**Subject SSS Listing & Concept Plan (MP10_0090) for Minmi, Newcastle Link Road
 And Stockrington For 3300 Lots, Mixed Use Development And The
 Dedication Of Approx 1,561 Hectares For Conservation**

Schedule Of Issues

Proposed SSS Listing & Concept Plan (MP10_0090) For Minmi, Newcastle Link Road And Stockrington For 3300 Lots, Mixed Use Development And The Dedication Of Approx 1,561 Hectares For Conservation – Lake Macquarie City Council Submission

Figure B.1.1. Conceptual Access & Movement

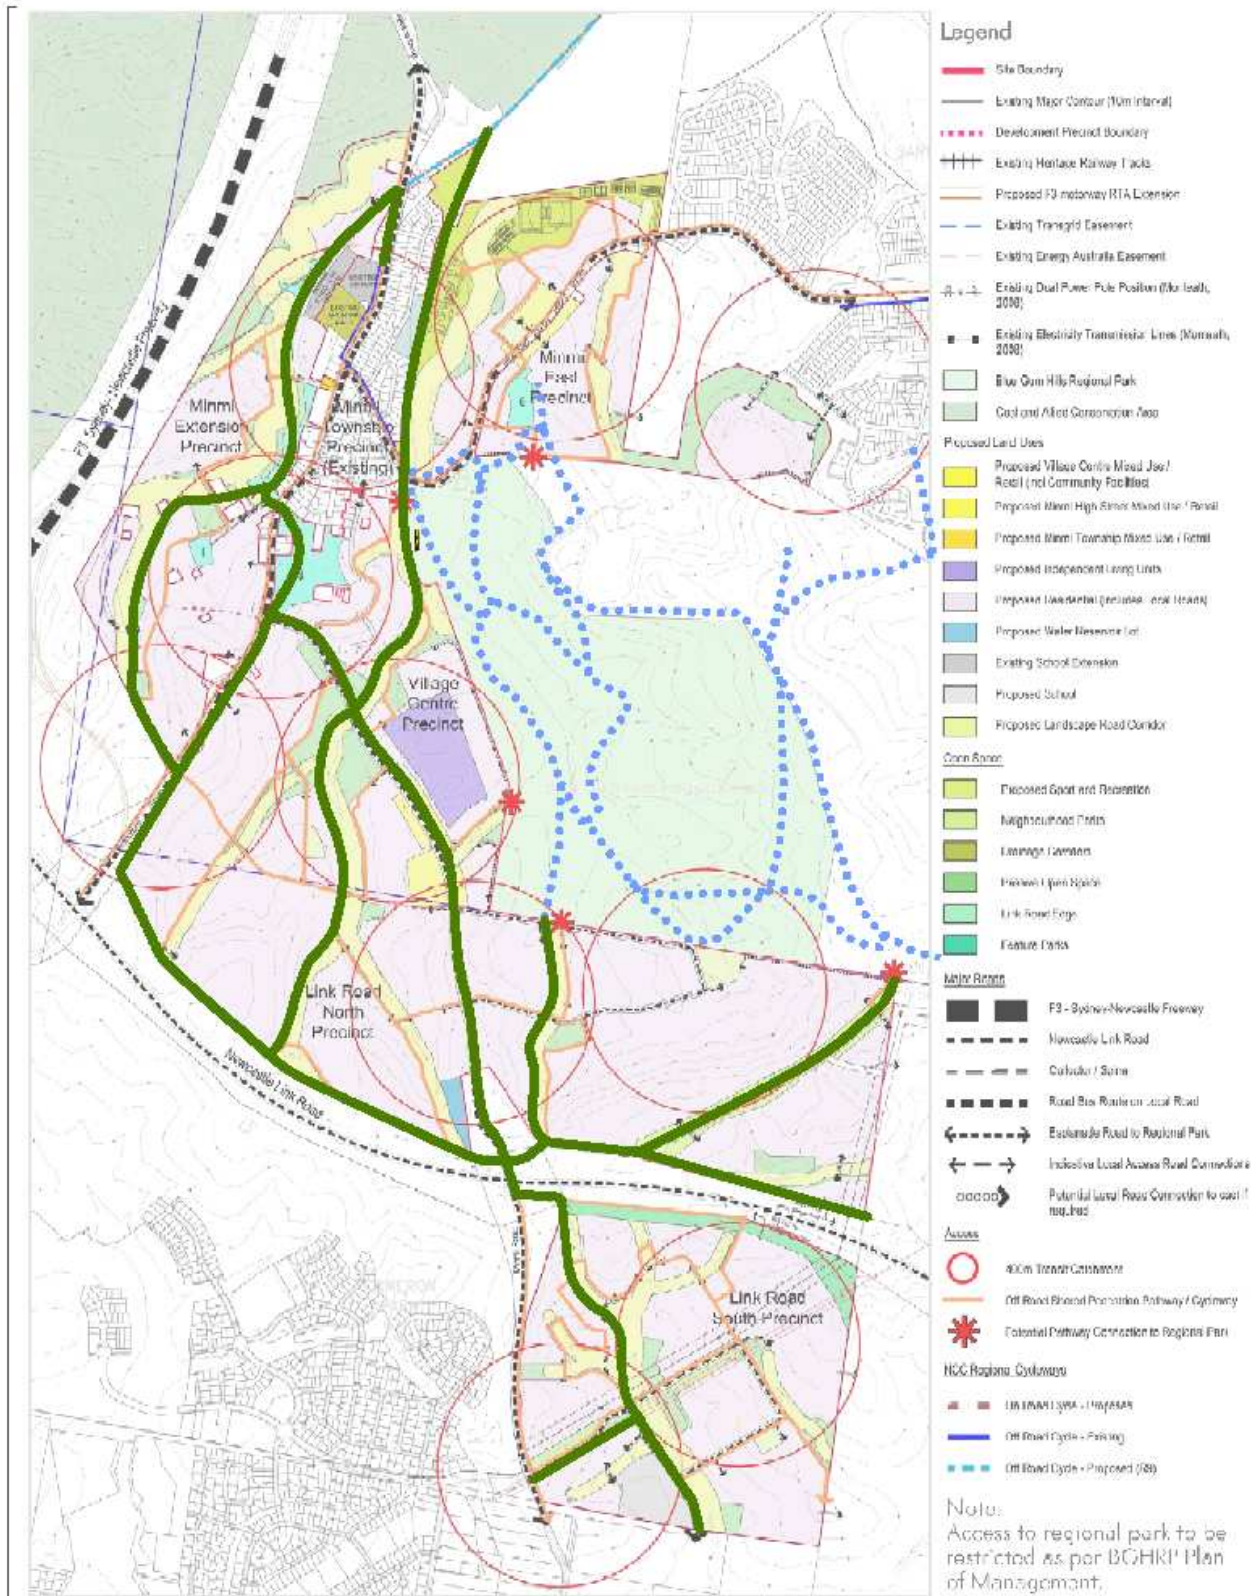
The CP provides a Conceptual Access & Movement plan in Figure B.1.1. This plan indicates the proposed 'off road shared pedestrian pathway/cycleway' routes. However, it does not differentiate between the pedestrian pathways and cycleways. This distinction is essential, as pathways are primarily for pedestrian use but allow cyclists under 12 year of age only, whereas off-road cycleways or shared pathways provide for pedestrian and cyclists of all ages.

Some of these routes identified in Figure B.1.1. particularly in the Link Road South Precinct, are a spaghetti-like network that weave in and out of the drainage corridors. These routes serve more of a bush fire control purpose than a shared pathway recreational/purpose

Blue Gum Hills Regional Park (BGH Regional Park) - Figure B.1.1 of Appendix B Concept Plan Design Guidelines (CP), indicates the potential pathway connection points to the Regional Park. Some of these access points do not appear to be in accordance with the proposed path network in Figure 8.35 of the BGH Regional Park Draft Plan of Management (BGH PoM). An access point is indicated in the BGH PoM but not in the Figure B.1.1 of the CP. The BGH Regional Park Fire Management Strategy 2005 indicates the service road access points that are required for fire management purposes.

As a starting point, LMCC has prepared plan identifying some possible off-road cycleways/shared pathways for discussion between the different agencies namely, the proponent, NCC, LMCC and RTA. This plan uses a copy of Figure B.1.1 of the Concept Plan which also indicates the level of proposed off-road shared pedestrian pathway/cycleways proposed by the Concept Plan, which are shown by an orange unbroken line. This plan is appended to this submission. Other off-road shared pathways include:

Outcome: The CP, Appendix B, Figure B.1.1. identifies the Conceptual Access & Movement plan indicates the 'Potential Pathway Connections to Regional Park'. These access locations do not appear to represent the access points as outlined in the BGH Regional Park PoM. The PoM identifies a pedestrian route system – Figure 8.15; a cycle route system - Figure 8.16; and a horse trail system Figure 8.17. Service vehicle road access points have also been identified in the *Hunter Region BGH Regional Park Fire Management Strategy (Type 2) 2005*. These access points have not been identified in Figure B.1.1

The CP, Appendix B, Figure B.1.1 has identified access points but these appear to be the access points proposed by the proponent they are not the access points identified by the BGH Regional Park PoM or the BGH Regional Park Fire Management Strategy.

The applicant is required to provide a cycleway network plan. The plan needs to show how the proposed 'cycleway access has been provided within and to the site that connects to all relevant transport services, existing and proposed adjoining suburbs and other key off-site locations (e.g. schools, shops, parks, recreation and community facilities)', as in accordance with the DGEARs.

The network plan is required to clearly demonstrate the location of the proposed pedestrian pathways (usually 1.2 metres wide), the on-road cycleways (proposed 1.5 metres wide) and the off-road shared pathways (usually 2.5 to 3.0 metres wide).

Community Planning Response: A CP that details all the proposed routes within the BGH Regional Park and all the access points, including service vehicle access points is required to be provided. The applicant is then able to demonstrate that the proposed development has been designed to link in with the existing and proposed development of the BGH Regional Park.
